## **9.4 Air Conditioning, Heating, Cooling and Ventilating Systems**

The information in this section of the reference ABWR DCD, including all subsections, tables, and figures is incorporated by reference with the following departures and supplements.

Figure 9.4-2c Turbine Building Electrical Equipment Areas (EEA) HVAC System Diagram

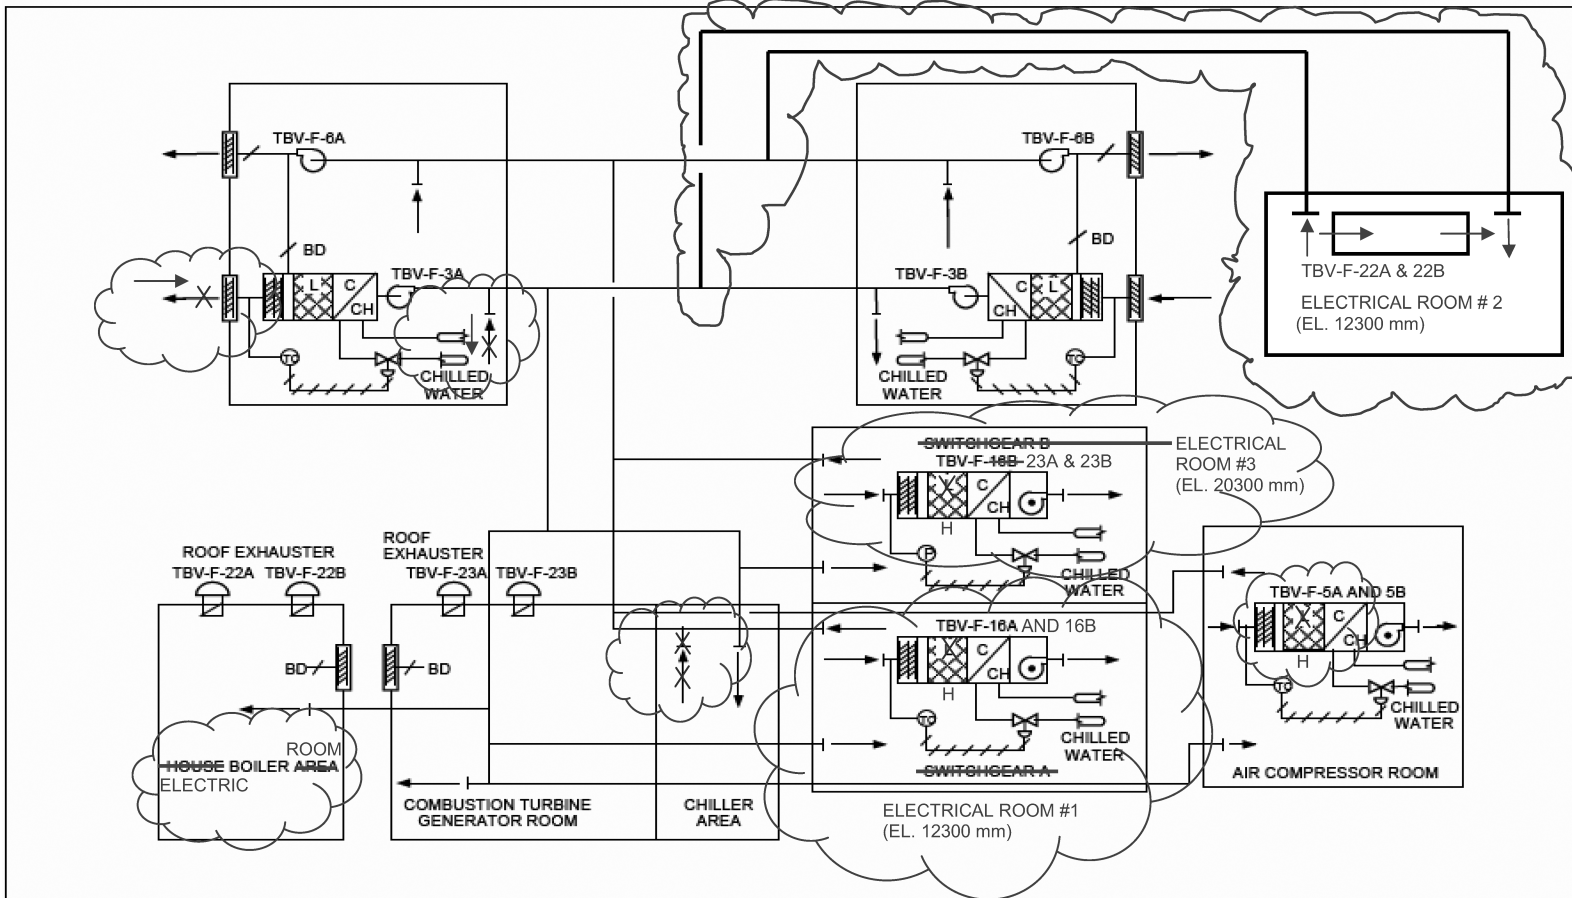
The ~~E/B~~ EEA HVAC schematic diagram is shown on Figure 9.4-2c.

The Electrical ~~Building~~ Equipment area HVAC System is provided with two 100% capacity air supply fans and two 100% capacity exhaust fans.

The air supply fan draws outside air through louvers, control dampers, low efficiency filters, electrical heating coils, and chilled water coils, and discharges air directly into the ~~switchgear~~ electrical rooms, chiller, combustion turbine generator, ~~house~~ electric boiler room and air compressor rooms. Return air ~~Ductwork~~ ductwork and ~~bypass dampers are~~ is provided to allow recirculation of air from the ~~switchgear~~ electrical rooms and ~~chiller rooms~~ air compressor room.

The ~~E/B~~ EEA HVAC system maintains the Electrical ~~Building~~ Equipment Areas at a positive pressure with respect to atmosphere.
